DEVELOPMENT REVIEW BOARD REPORT

One Scottsdale PU III, QuikTrip and Conceptual Master Site Plan update 61-DR-2015#6	Request for approval of the site plan, landscape plan, and building elevations for a new gas station with 16 fuel pumps and convenience store with approximately 12,657 square feet of building area on a +/- 2-acre site, along with a revision to the previously approved conceptual master site plan of case 61-DR-2015#5 for the larger +/- 21.6-acre site.
--	---

61-DR-2015#6

SHEET NUMBER:
 L100

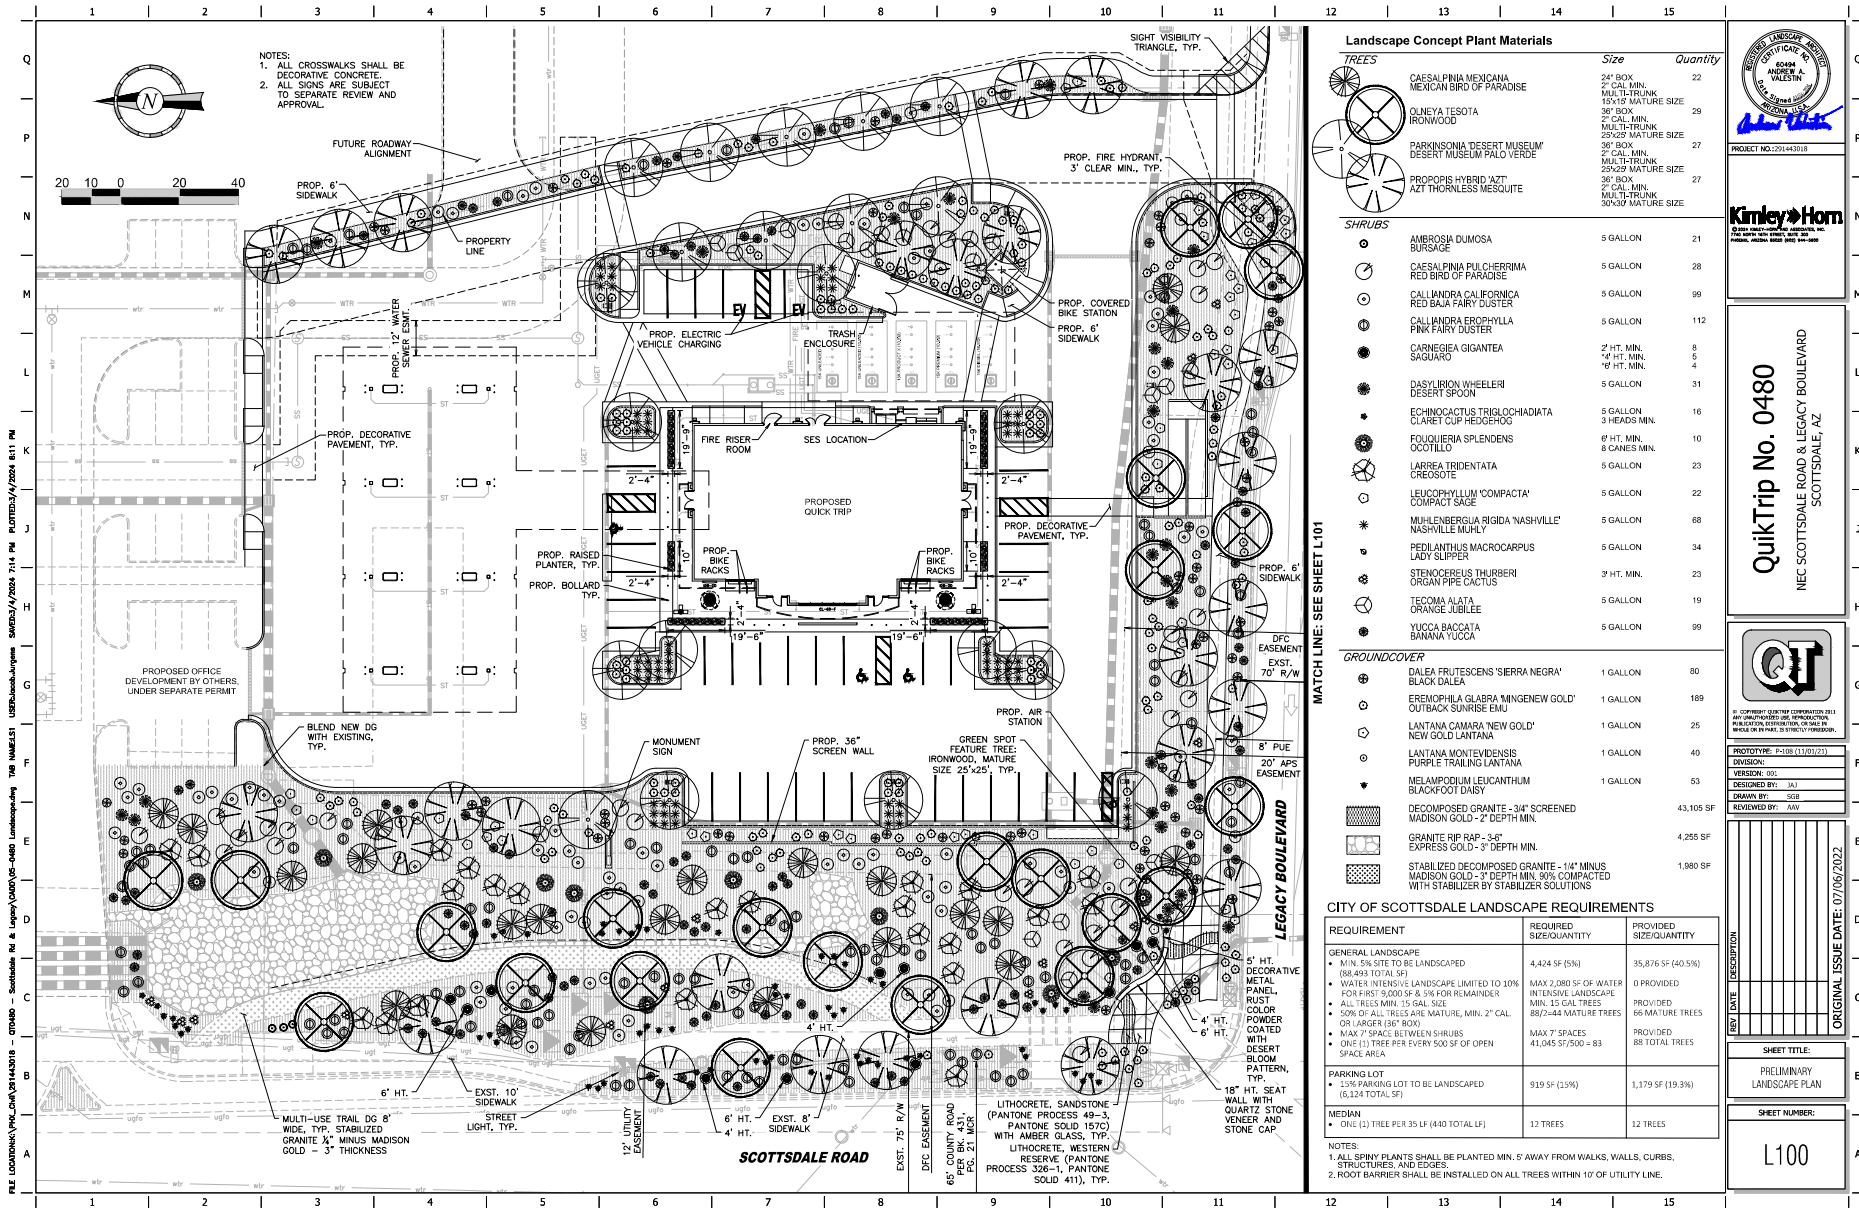
- Sidewalk along Legacy Boulevard reconfigured to accommodate trees and other plants along the southside of the sidewalk for pedestrian shade.
- Internal sidewalk along eastern portion of the site reconfigured to accommodate mature trees and other plants along the west side of the sidewalk for pedestrian shade.
- Gas vents removed from the top of fuel canopy and relocated behind the trash enclosure to adequately screen from public streets.
- Landscape plan updated to conform with the Scottsdale Streetscape Design Guidelines, Green Spot site design requirements located at the intersection of N. Scottsdale Road and E. Legacy Boulevard. Green Spot features include quartz stone seat wall, Desert Bloom patterned screen panel, and lithocrete custom color accent paving with recycled glass aggregate.

- c. Landscape improvements, including quantity, size, and location shall be installed to be consistent with the preliminary landscape plan submitted by Kimley-Horn and Associates, Inc, with a city staff date of April 8, 2024.

SHEET TITLE:
EXTERIOR ELEVATIONS

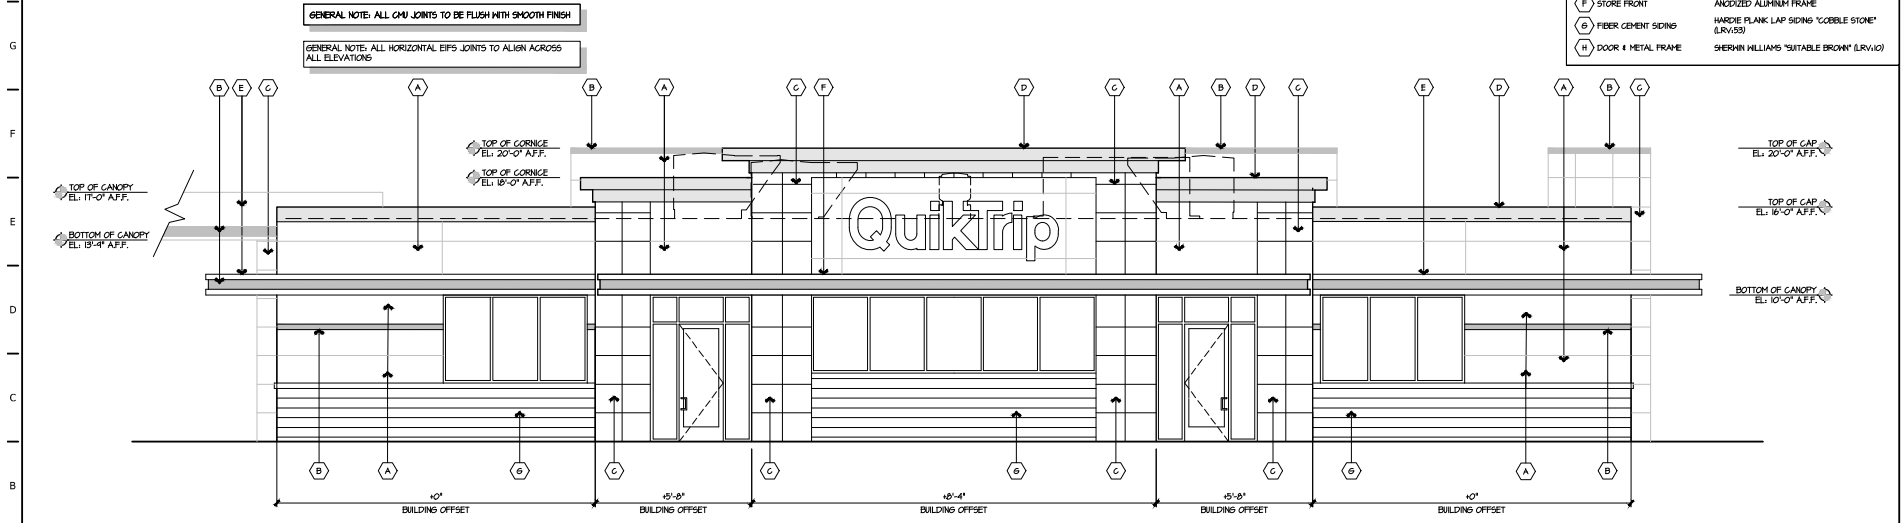
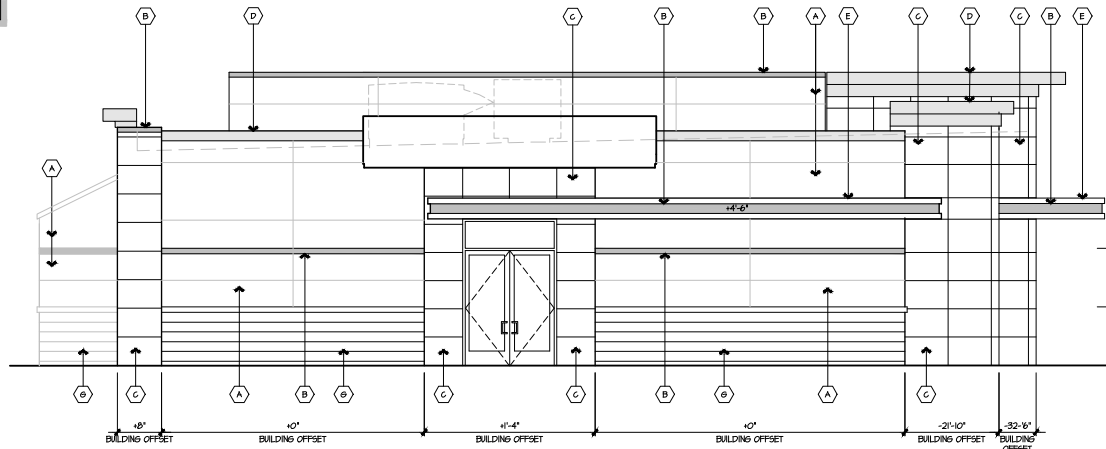
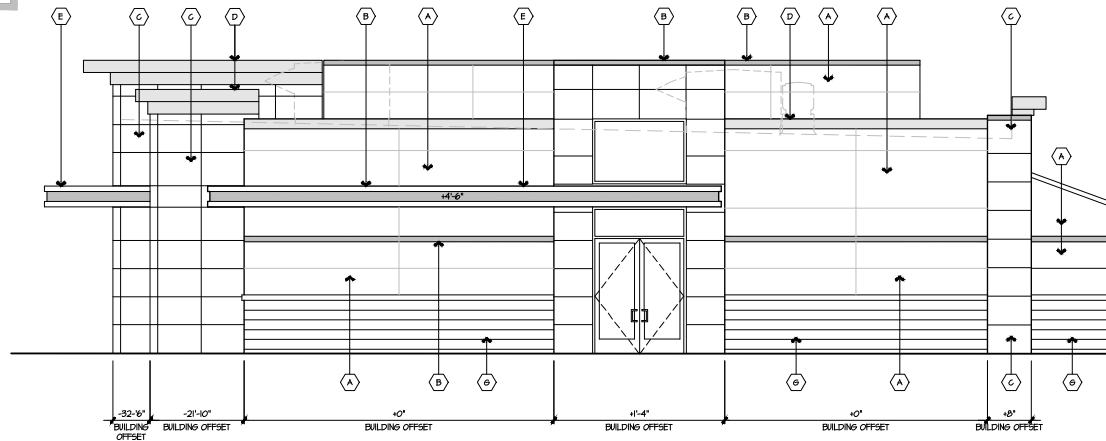
- *Staff finds that the mechanical equipment is integrated into the building design and rooftop units are fully screened by the parapet walls.*
5. Within the Downtown Area, building and site design shall:

2. All exterior window glazing shall be recessed a minimum of fifty (50) percent of the wall depth, including glass windows within any tower/clerestory elements. The amount or recess shall be measured from the face of the exterior wall to the face of the glazing, exclusive of external detailing. With the final plan submittal, the developer shall provide head, jamb and sill details clearly showing the amount of recess for all window types.

3. All exterior doors shall be recessed a minimum of thirty (30) percent of the wall depth, the amount of recess shall be measured from the face of the exterior wall to the face of the glazing, exclusive of external detailing. With the final plan submittal the developer shall provide head, jamb and sill details clearly showing the amount of recess for all door types.
